MIL-R-23016(WEP)
 Amendment 3
15 December 1964
 Superseding
 Amendment 2
 15 March 1963

MILITARY SPECIFICATION

RADIO SET AN/ARC-94

This amendment forms a part of Military Specification MIL-R-23016(WEP) dated 16 October 1961 and has been approved by the Bureau of Naval Weapons, Department of the Navy.

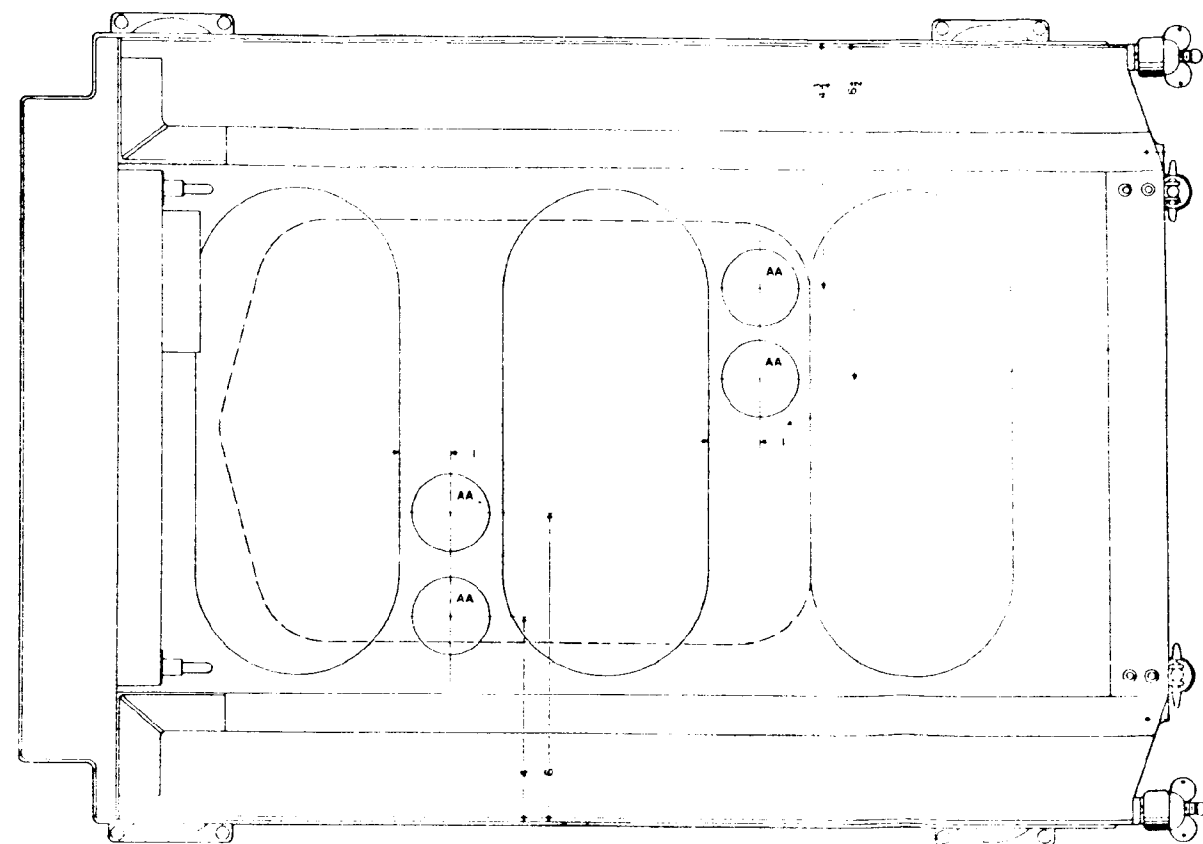
*Page 116, Delete Figure 33 and substitute the following new Figures:

"Figure 33	Transmissibility vs Frequency -- Types I and IV
Figure 34	Type II Receiver Transmitter
Figure 35	Type II or III Receiver Transmitter
Figure 36	Transmissibility vs Frequency -- Retrofit in a MT-1415/ARC-38 - Types II or III
Figure 37	Type II Power Supply"

TYPES II or III REC/TRAN.
FIGURE 35

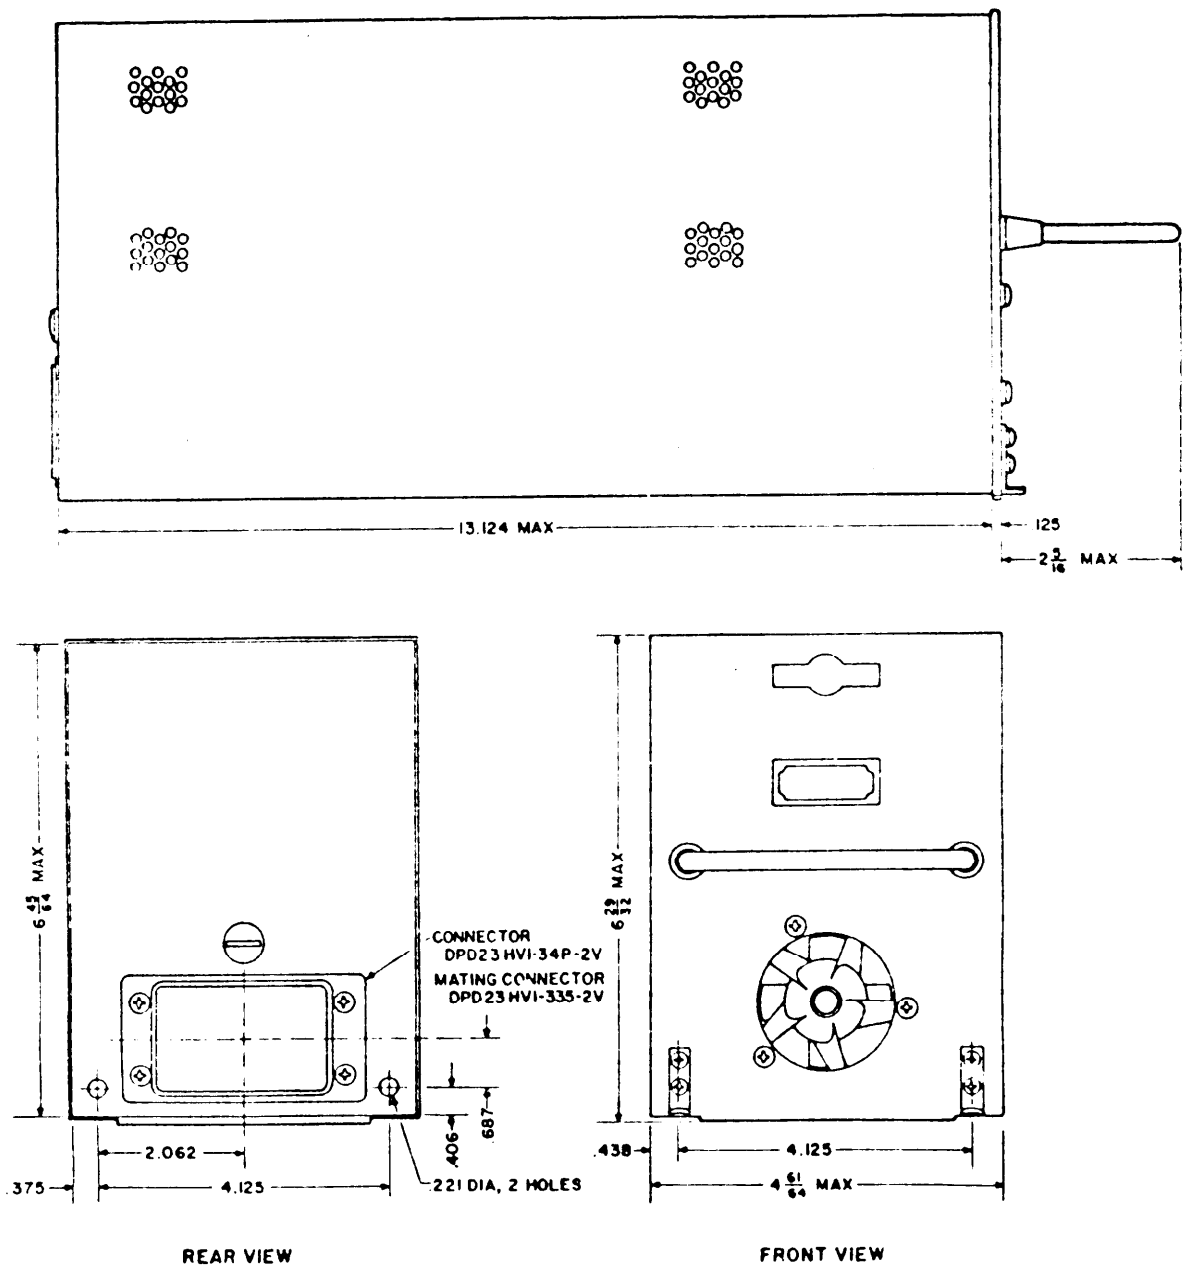
The 350S-1, 350S-3 and MT-1415/ARC-38 are produced with either a rectangular cut-out (not shown) or oval cut-outs as shown. Trays with rectangular cut-outs allow discharge of the exhaust air for proper operation of the Type II or III Rec.-Transmitter. The Type II or III units will operate on a reduced rating when adapted to mounts having oval cut-outs. The manufacturer strongly recommends that the (4) holes "AA" be punched in the positions shown using a 1-1/2 diameter Greenlee punch or equivalent for increased performance and maximum reliability of the Type II or III units. The cup portion of the Greenlee punch should be placed on the top side of the mount floor to avoid distorting the tray during punching operation.

1. Clearance for sway movement of unit on vibration mount equals 1/2 inch on all side.
2. Pendant cable as shown is part of Type III retrofit adapter only. The Type II retrofit adapter does not have pendant cable.

This area may be removed on 350S-() or MT-1415/ARC-38 for clearance of pendant cable on **Type III retrofit adapter** (see Note 2).

TRANSMISSIBILITY VS FREQUENCY
TYPE II & III RETROFIT IN A MT1415/ARC-38

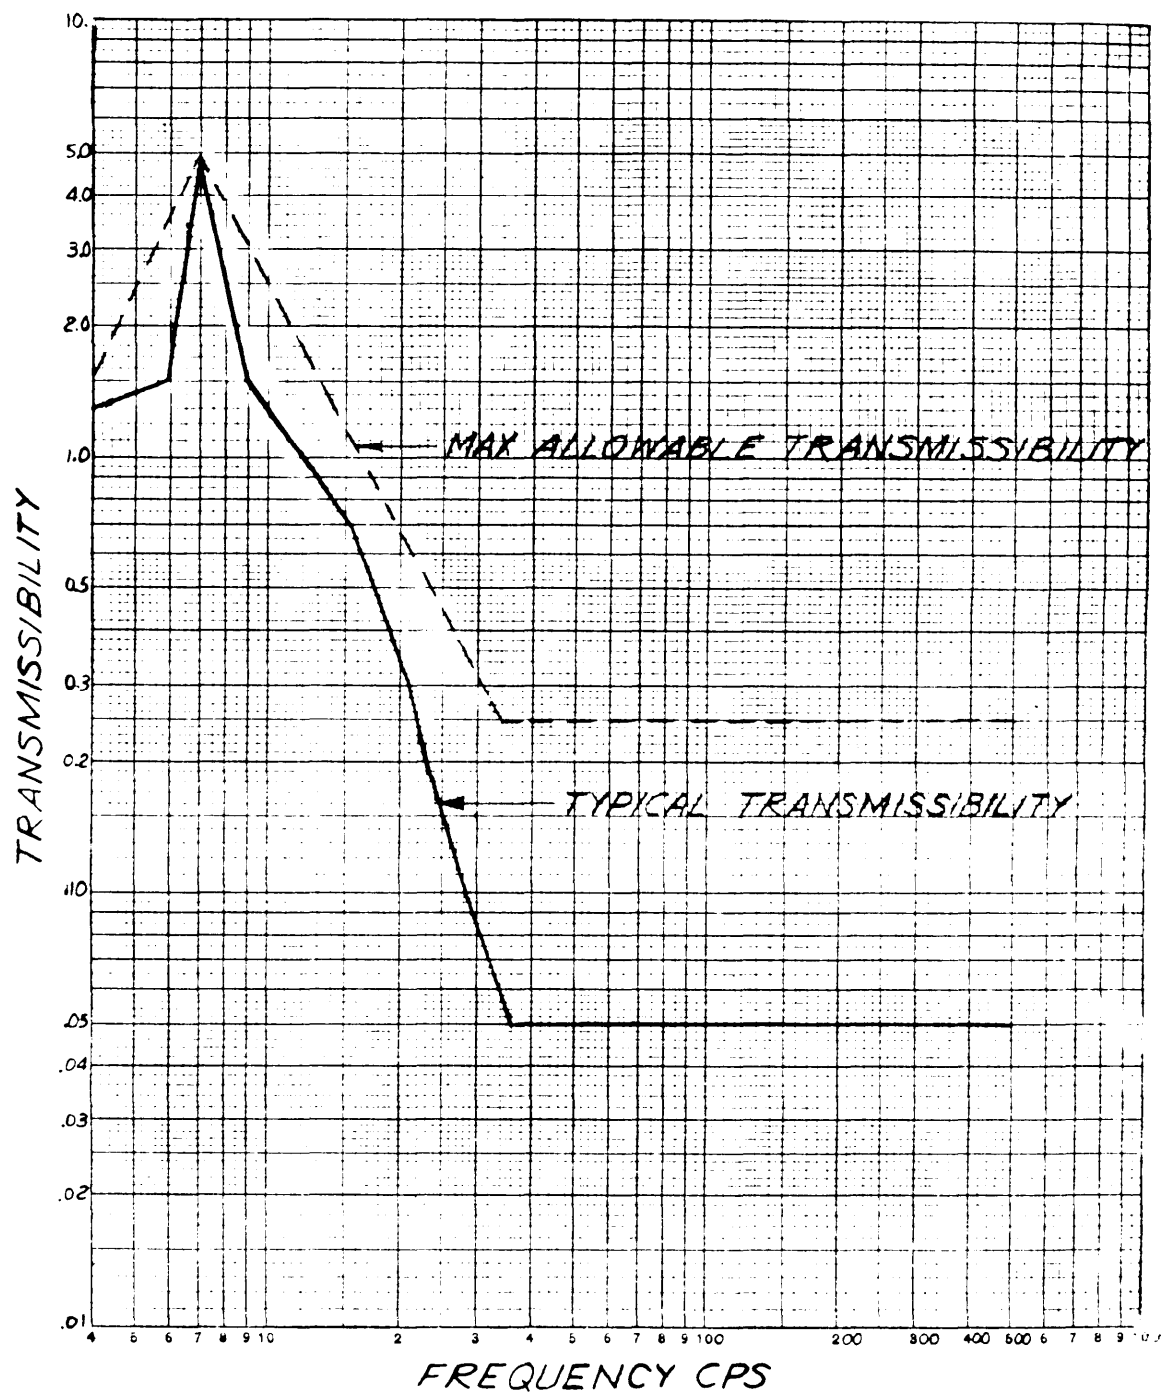
"3.3.4.3.1 Function: The Type I and Type IV equipment mounting, MT-2641/ARC-94, shall have the transmissibility shown in Figure 33 to allow the equipment to perform under the specified environmental requirements. The Type II and Type III equipment retrofit adapter mounts, MX (*)/ARC-(*) and MX (*)/ARC-(*), shall have the transmissibility shown in Figure 36 to allow the equipment to perform under the specified environmental requirements."
